KEY SWITCH REPLACEMENT

Quicksilver Parts Affected

a - Date code and key number
b - Key switch

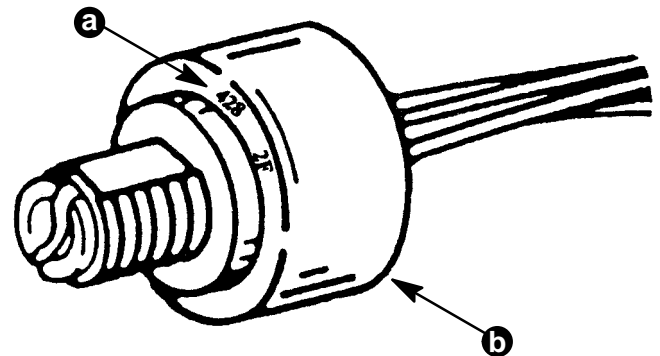
Electric start outboards using the above listed Quicksilver remote control and key switch/harness assemblies have experienced failures of the key switch tumbler springs. The failure results in the inability to turn the key to the run or start position. The failures have been isolated to three key switch manufacturing date codes 424, 428, and 450.

Date code and key number explanation:

Remove from package and check date code on key switch. On inspection of key switch, if date code is 424, 428, or 450 complete and submit a warranty claim for credit. Any of the above listed assemblies with key switch date codes other than 424, 428 or 450 are good serviceable items.

- a - Screws
- b - Back Panels
- c - Retainer Nut
- d - Key Switch

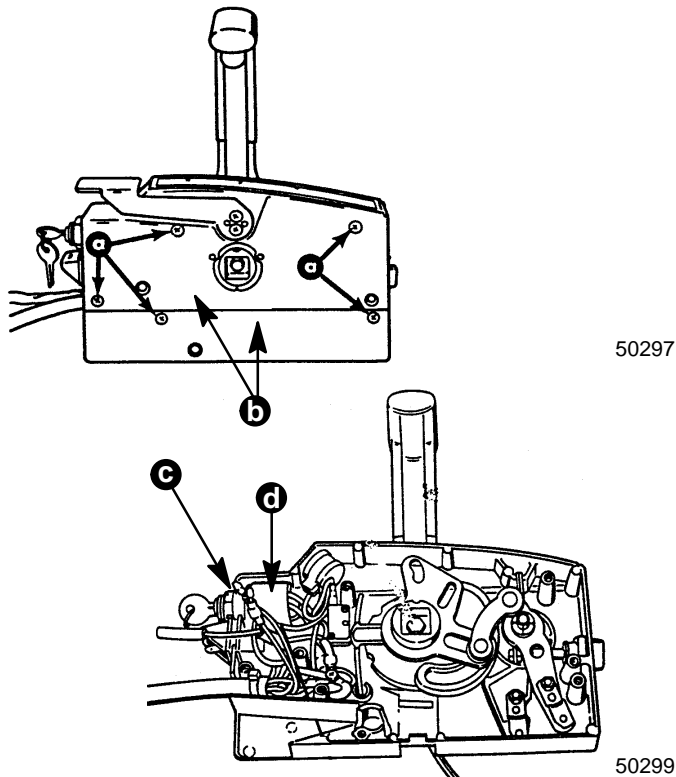
Remove remote control from the package. Remove 5 screws (a) and upper and lower back panels (b). Loosen key switch retainer nut (c) pull key switch (d) from control box housing and check date code. If date code on key switch is 424, 428, or 450 replace the key switch with P/N 87-17009A2, reassemble and re-package.
